**Lecture by Dr. Stig Bernander**  
**on “Quick Clay “ and**  
**The North Spur**

Memorial University  
St. John's, NL  
October 31, 2014

### 3. **NALCOR assessments** (Ref Nalcor July 21, 2014 North Spur Updated as per Nalcor website)

## Assessment 4

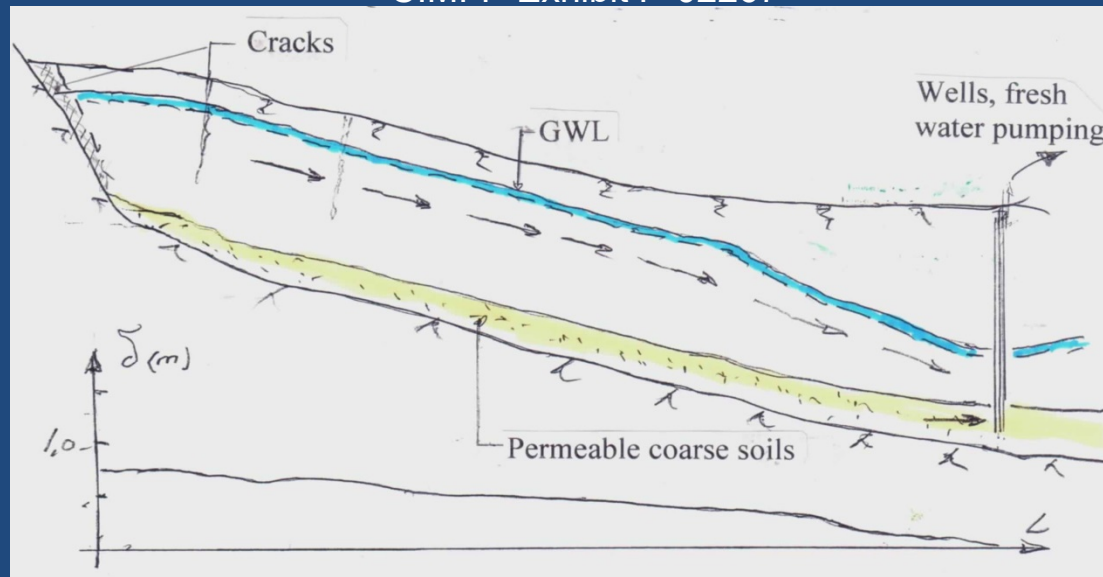
“Counter measure will be in place to control “Human triggering”

### *Comment:*

*Not valid because Nalcor has not based its analysis on a **Progressive Failure Mode**.*
